TURKEY POINT NUCLEAR GENERATING STATION UNIT 3 AND UNIT 4

IMPROVED TECHNICAL SPECIFICATIONS CONVERSION

ITS CHAPTER 2.0 SAFETY LIMITS (SLs)

**Current Technical Specification (CTS) Markup
and Discussion of Changes (DOCs)**

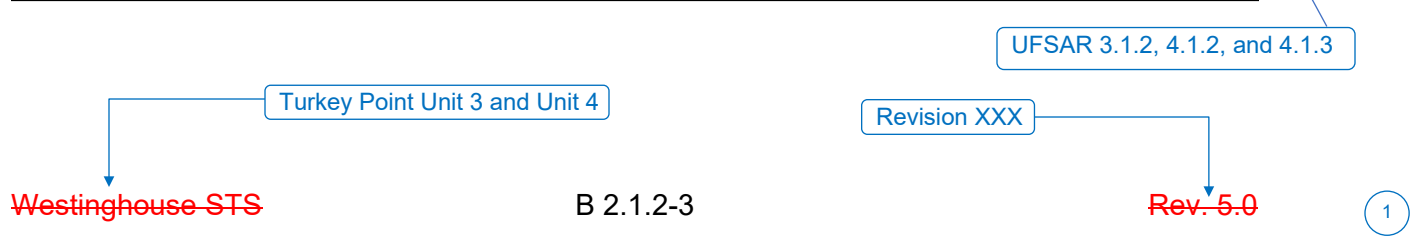
SAFETY LIMIT VIOLATIONS If the RCS pressure SL is violated when the reactor is in MODE 1 or 2, the requirement is to restore compliance and be in MODE 3 within 1 hour.

Exceeding the RCS pressure SL may cause immediate RCS failure and create a potential for radioactive releases in excess of 10 CFR 100, "Reactor Site Criteria," limits (Ref. 4).
